**1.2 1221-1249 CENTRE ROAD, OAKLEIGH SOUTH
USE AND DEVELOPMENT OF THE LAND FOR PRELOADING OF EARTH AND
CONSTRUCTION OF BUILDINGS AND WORKS (TEMPORARY LANDFILL GAS
VENTING TRENCH) AND ALTERATION OF ACCESS TO A TRANSPORT ZONE, 2
(TPA/53179)**

EXECUTIVE SUMMARY:

This application proposes further remediation and rehabilitation works on the site of the former Talbot Road Quarry. Ground improvement works (pre-loading) and a temporary landfill gas venting trench are proposed in the north west corner of the site.

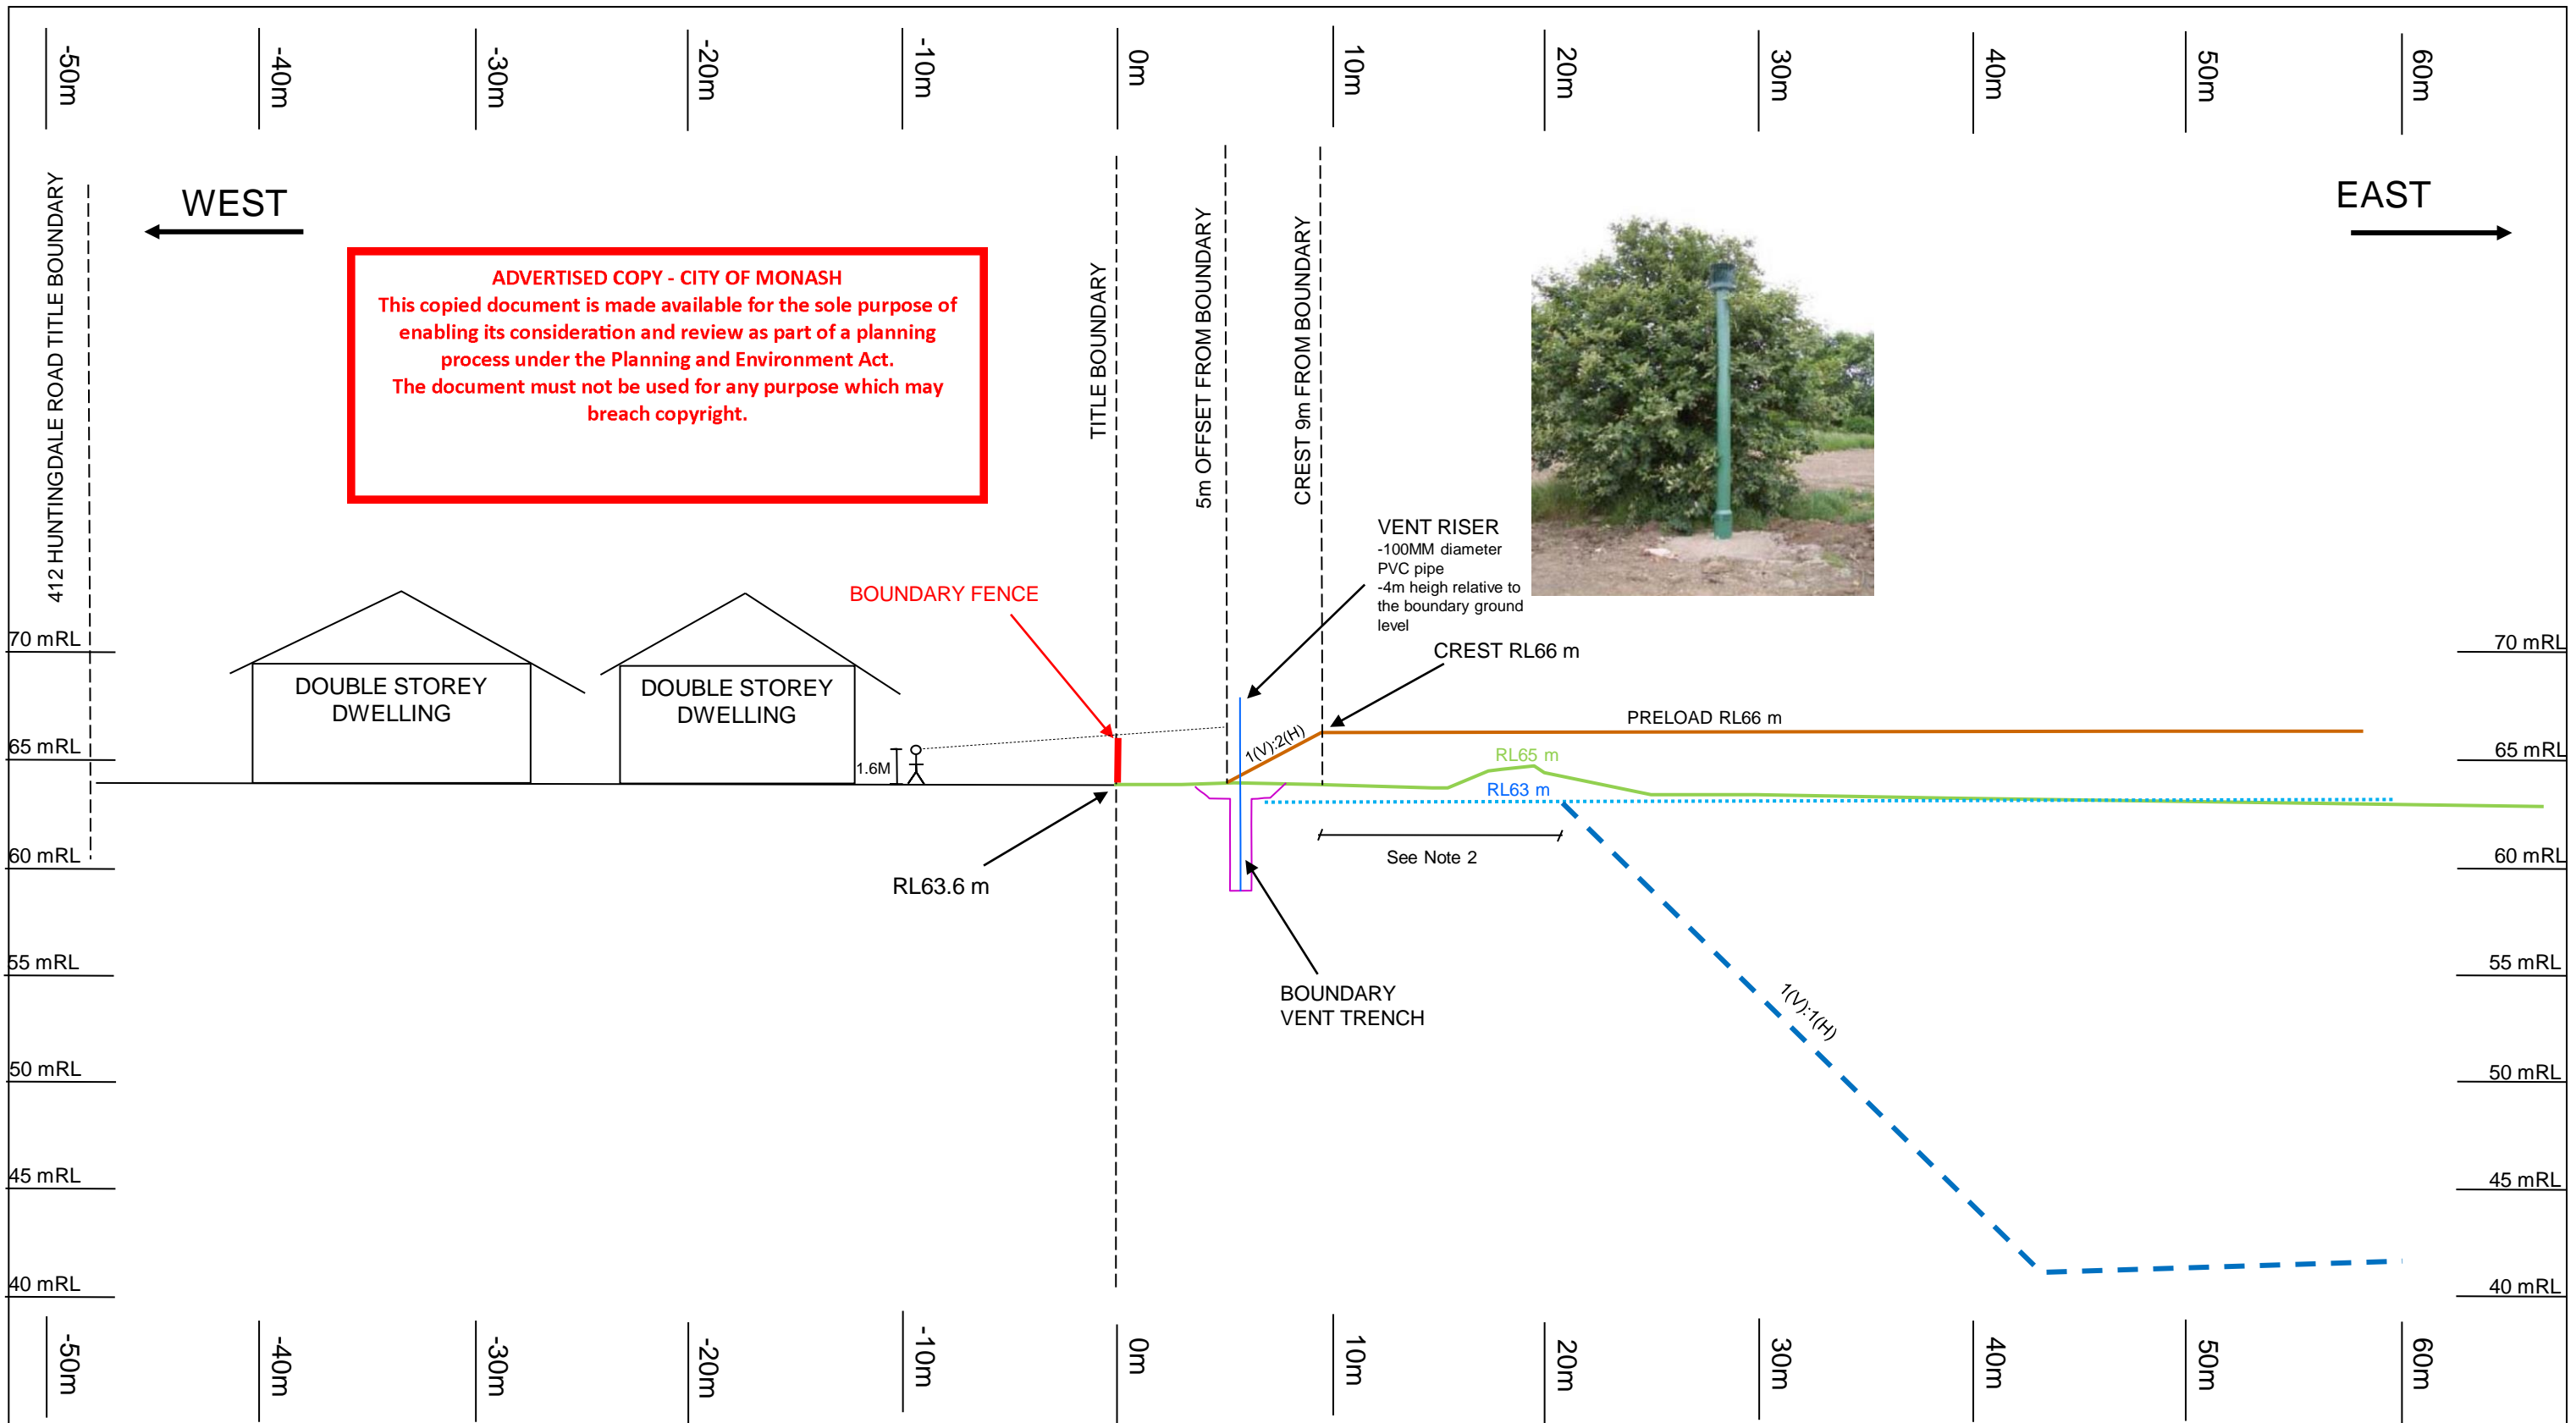
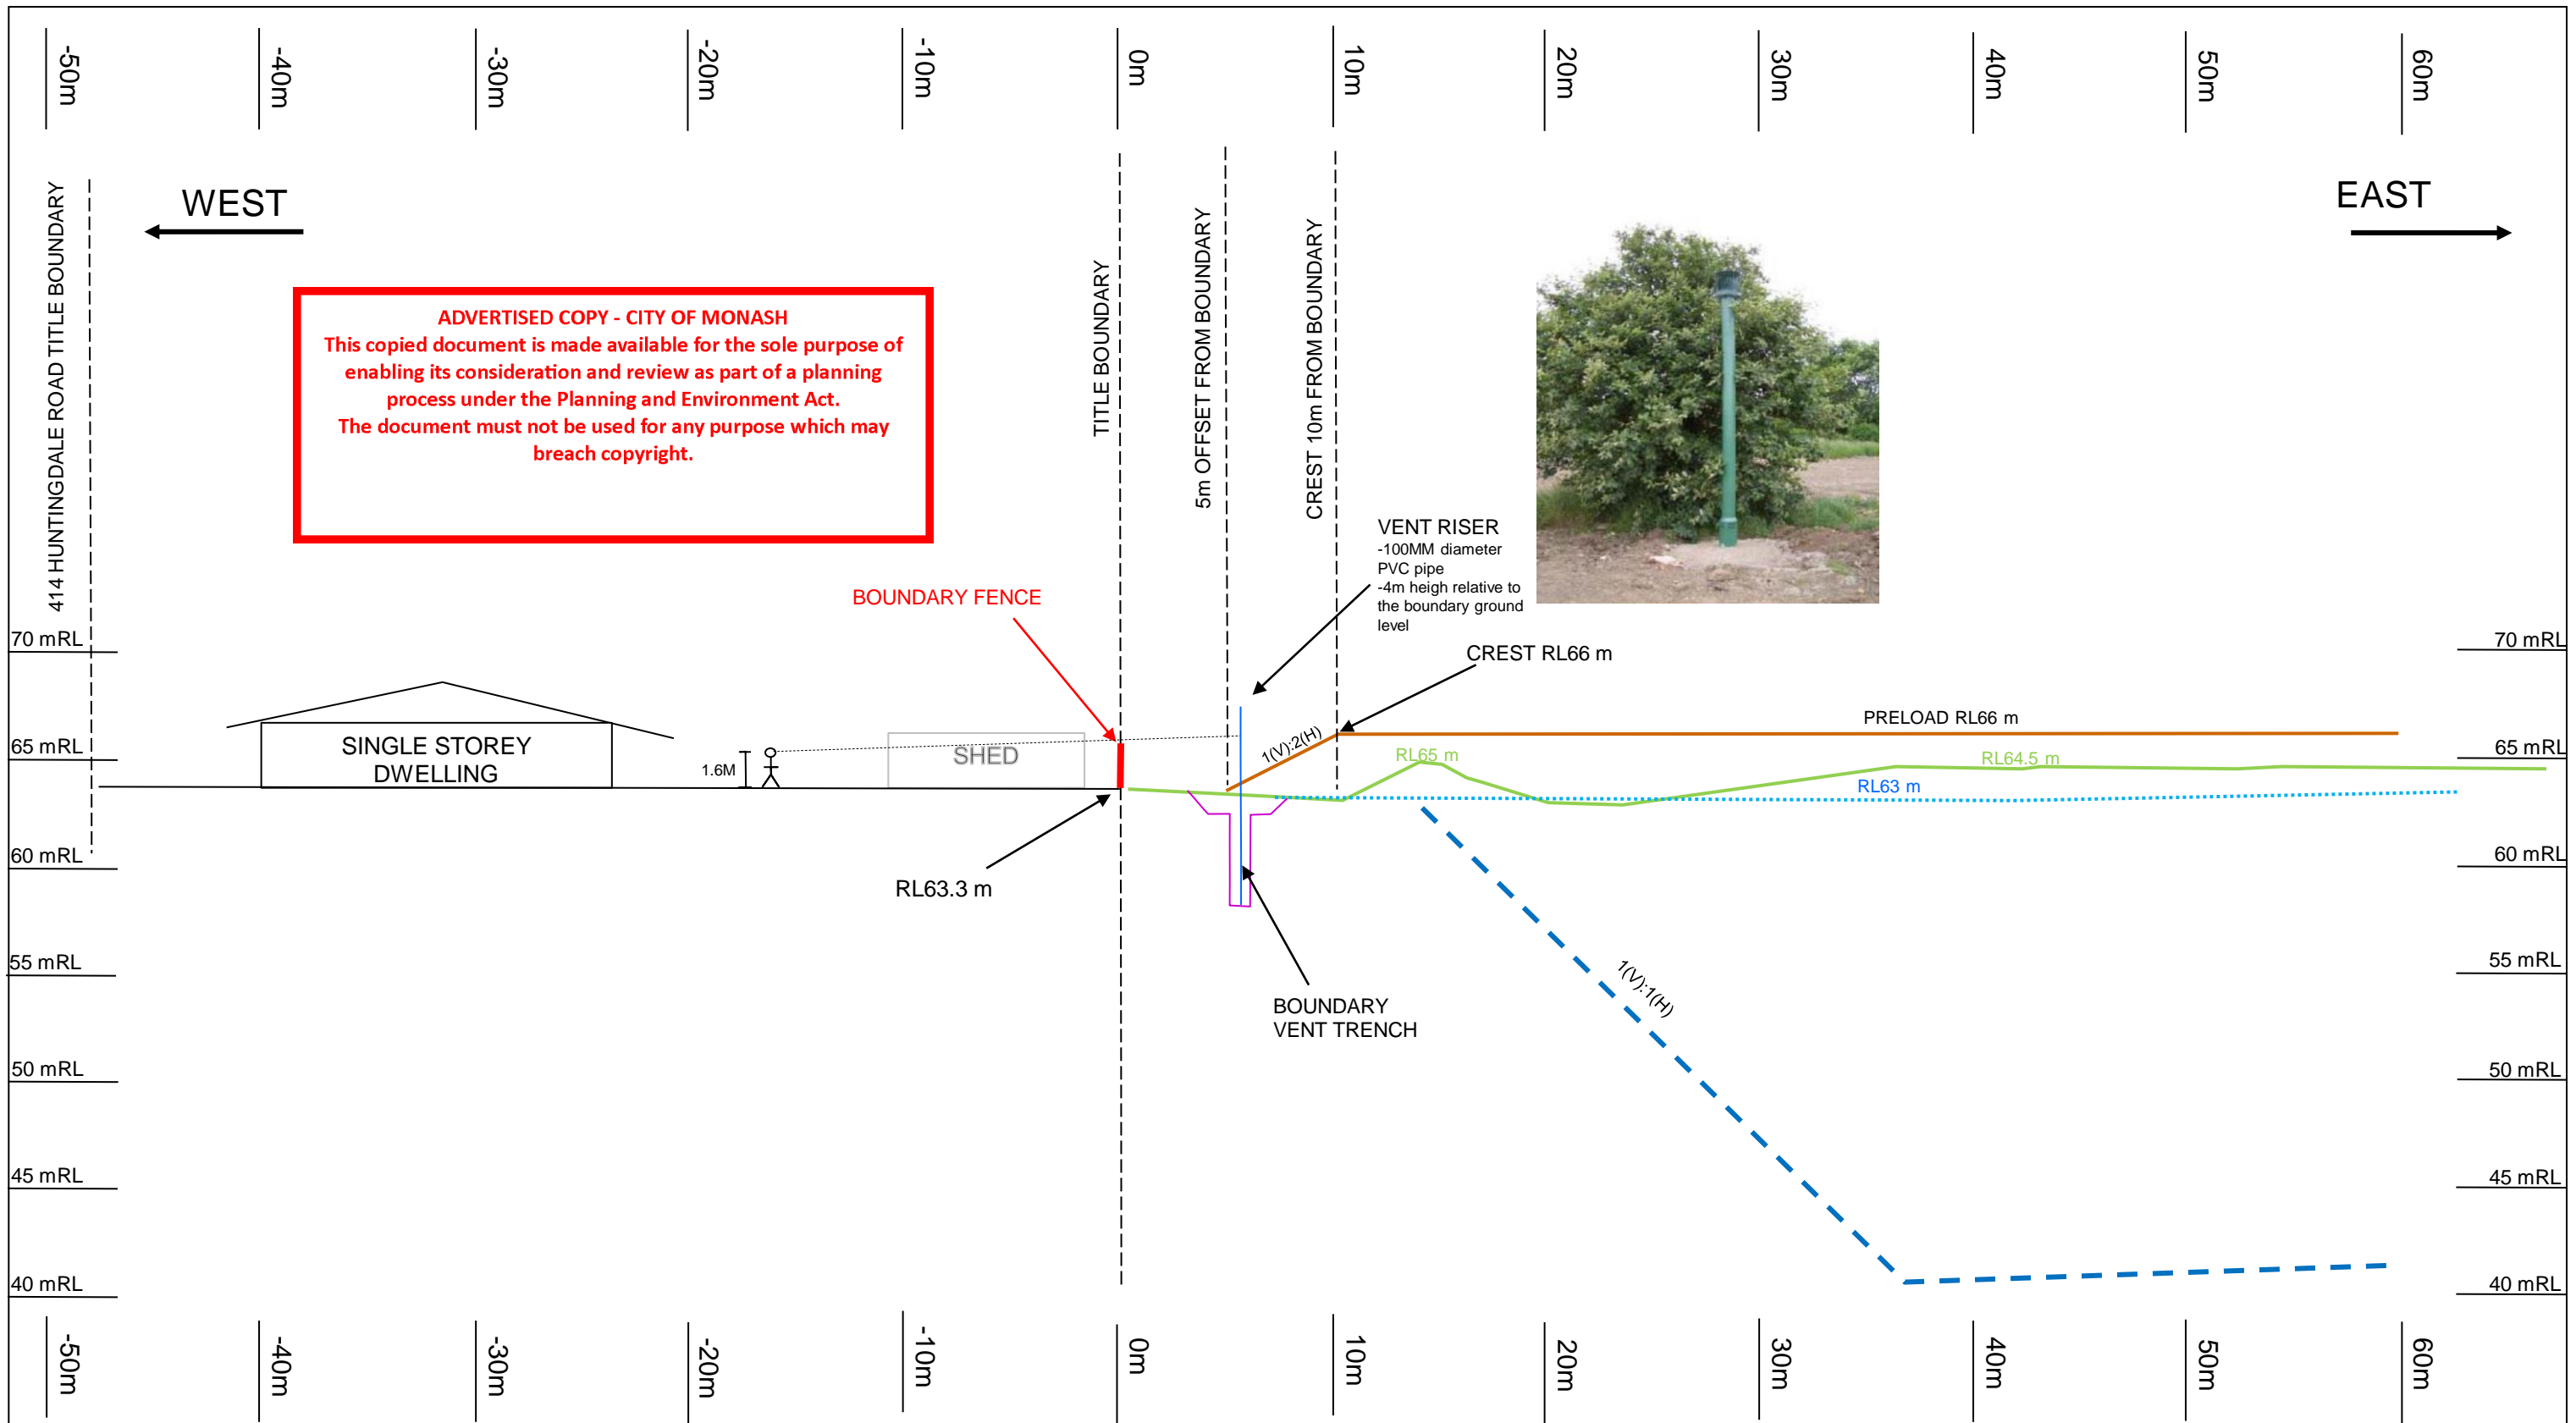
- a) The location and height of the proposed silt fencing to be shown on sectional diagrams prepared by Tetra Tech Coffey.
 - b) The location and minimum setbacks of the proposed swale drain to adjoining properties and identified on sectional diagrams on the plans prepared by Tetra Tech Coffey.

- Concern is raised with the slope of the batter in relation to the proximity of the boundaries and the interface with the residential properties. This will need to provide for a more gradual and gentle slope.

- The preload has been designed with a 5m buffer from the site boundary to the toe of preload batter. This enables the crest/top of the preload to extend to the edge of the pit crest to provide a uniform surcharge over the landfill to reduce subsequent total and differential settlement of the landfill capping layer and structural fill layers.
